UNITED STATES PATENT AND TRADEMARK OFFICE

APPLICATION NO.	FILING DATE	FIRST NAMED INVENTOR	ATTORNEY DOCKET NO.	CONFIRMATION NO.
10/763,070	01/22/2004	Jean-Luc Morand	S1022.81118US00	3710
23628	7590	05/17/2005	EXAMINER	
WOLF GREENFIELD & SACKS, PC FEDERAL RESERVE PLAZA 600 ATLANTIC AVENUE BOSTON, MA 02210-2211			NGUYEN, THINH T	
			ART UNIT	PAPER NUMBER
			2818

Office Action Summary	Application No. 10/763,070	Applicant(s) MORAND, JEAN-LUC	
	Examiner Thinh T. Nguyen	Art Unit 2818

DETAILED OFFICE ACTION

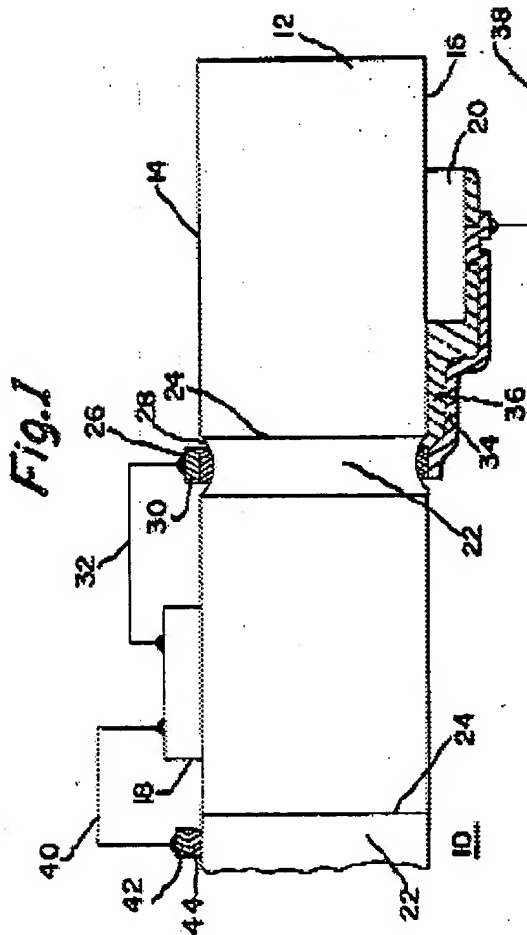
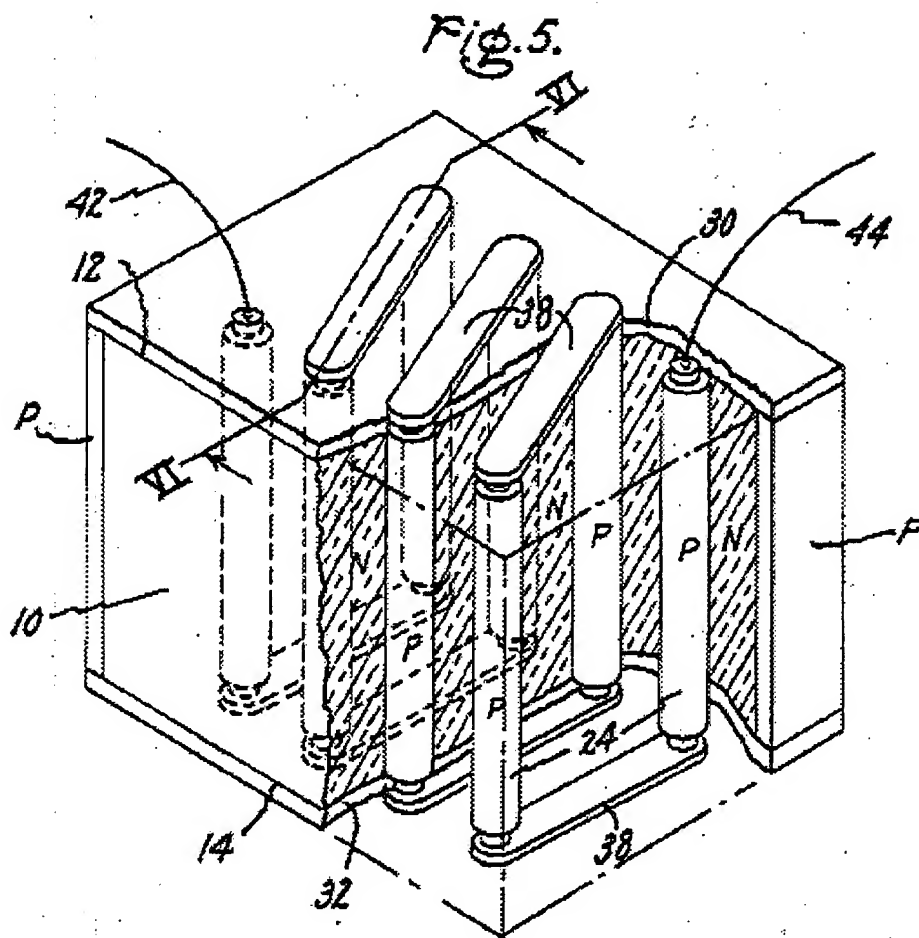
Anthony et al. (fig 1,the title, the abstract,), disclose a semiconductor component in which the active junctions extend perpendicularly to the surface of a semiconductor chip substantially across an entire thickness thereof. Similarly, Cline et al. disclose (fig 5) The same invention.

Anthony et al. (fig 1,the title, the abstract,), disclose a semiconductor component of wherein the contacts with the regions to be connected are provided by conductive fingers substantially crossing an entire region with which a contact is desired to be established.

Anthony et al. (fig 1, the title, the abstract, column 2 line 51-56), wherein the conductive fingers are metal fingers.

Fig. 3. INVENTORS
Robert Lindsay Rouse
James Wakefield
Ronald Charles Newman

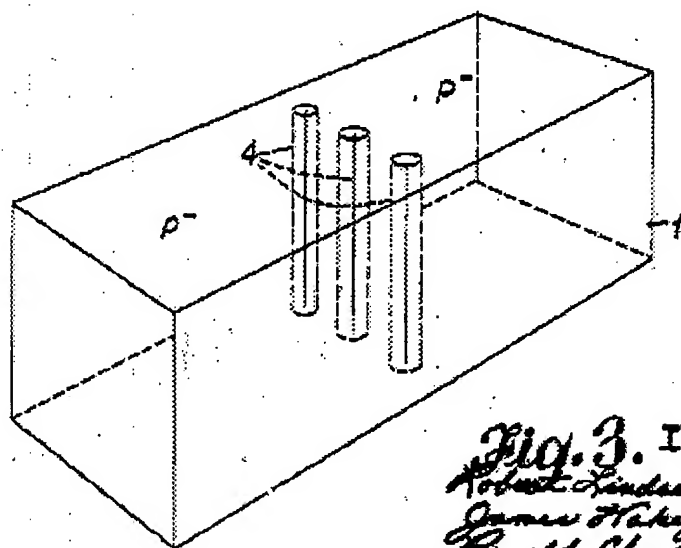
Rouse (fig 3) discloses a semiconductor component of multi-cellular type, wherein the junctions are formed of several cylinders perpendicular to the main substrate surfaces.

Fig. 5. INVENTORS
Robert Lindsay Rose
James Wakefield
Ronald Charles Newman
BY
Larson and Taylor

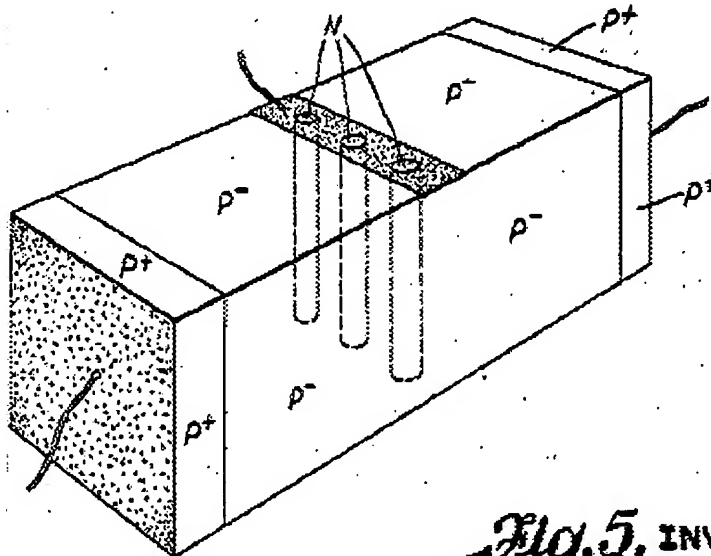
Rouse (fig 5) discloses a diode comprising an alternation of regions of a first conductivity type and of a second conductivity type extending across the entire substrate thickness, the regions of a first type being crossed by conductive fingers connected to a metallization extending over an entire surface of the substrate, and the regions of the

second type being crossed by conductive fingers connected to a metallization on the other substrate surface.

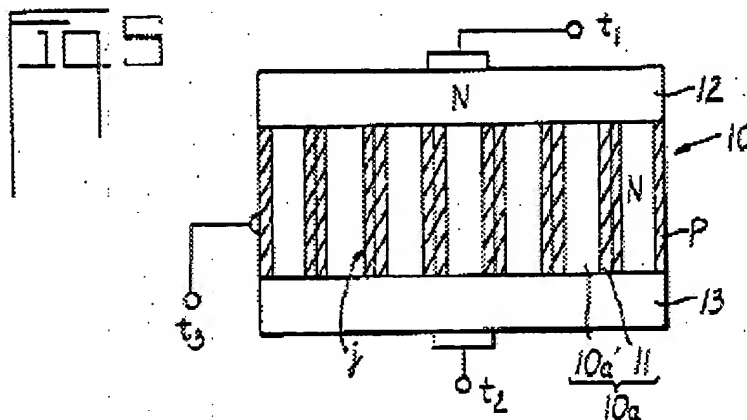
Rouse (fig 5,claim 2) disclose all the invention including a transistor device (see claim 2) except for the use of conductive fingers on all three transistor terminals. Kobayashi et al., (fig. 5), however teach how to connect conductive fingers to a three terminal devices.

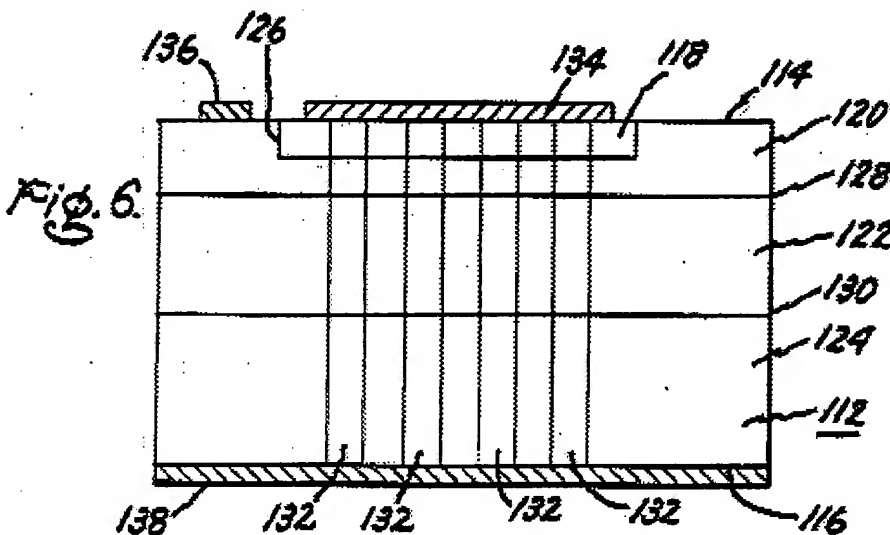
Krishna (fig 6) disclose all the invention including a thyristor device (column 1 line 14) except for the use of conductive fingers on all three thyristor terminals. Kobayashi et al., (fig. 5), however teach how to connect conductive fingers to a three terminal devices.
